**R66 F049 Engine Electrical Harness Installation Kit Instructions***(To comply with R66 Service Letter SL-41; Supersedes KI-268)**Applicable to helicopter S/N 0275 thru 1021; for prior helicopter serial numbers, refer to KI-223. Replaces previous F049-09 & F049-012 engine harnesses with new F049-012.***NOTE**

**FIGURE 1**

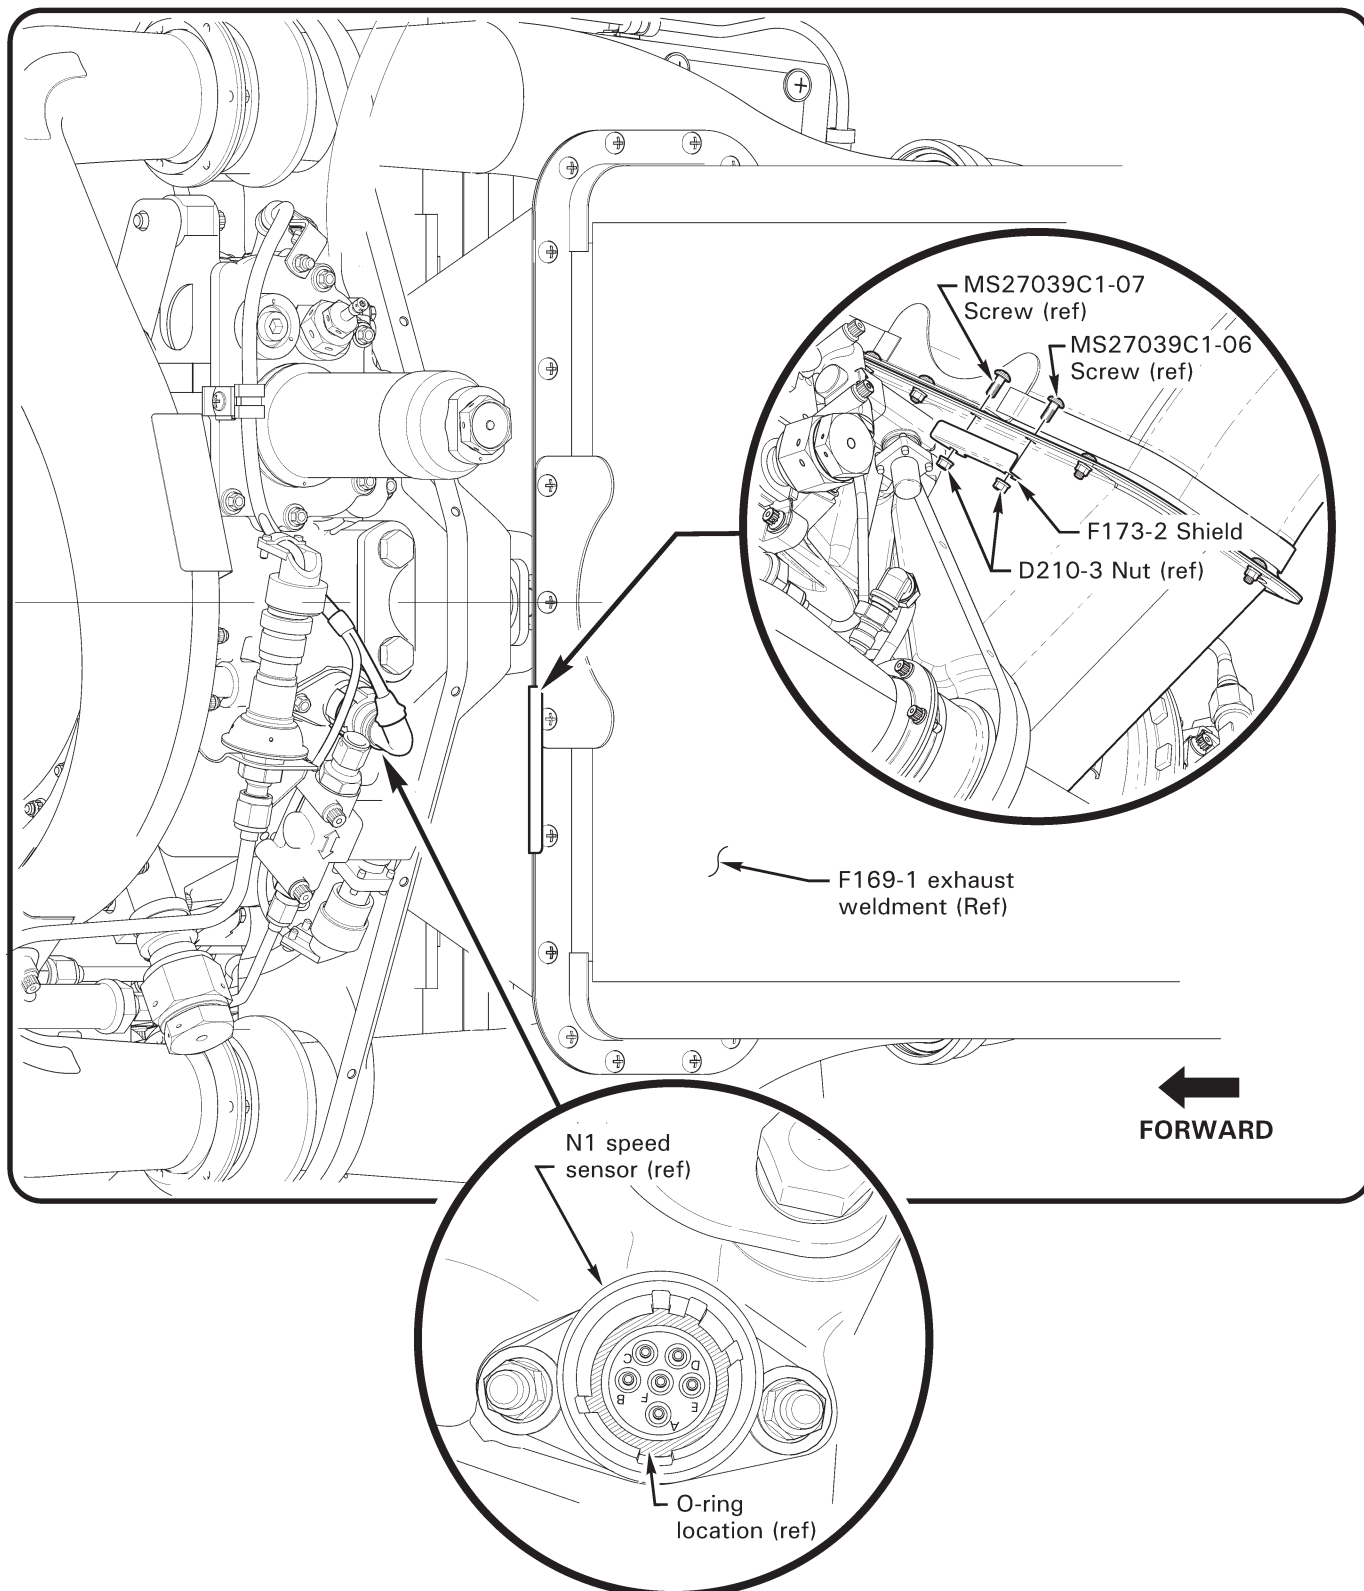
- a. Refer to Figure 1. Remove & retain one MS27039C1-06 screw & one MS27039C1-07 screw and two nuts at locations shown.
  - b. Install F173-2 shield as shown, using retained hardware. Standard torque screws per MM § 20-32.
8. Connect F049-012 (engine) electrical harness assembly to F059-01 (cabin) electrical harness assembly. Verify security. Secure F059-01 harness using appropriately-sized ty-raps as required.
  9. Connect battery negative (ground) cable per MM § 96-11 (lead-acid) or § 96-12 (lithium-ion).
  10. Install G040 engine cowling assembly per MM § 53-21.
  11. Make appropriate maintenance record entries. Weight and Balance change is negligible.
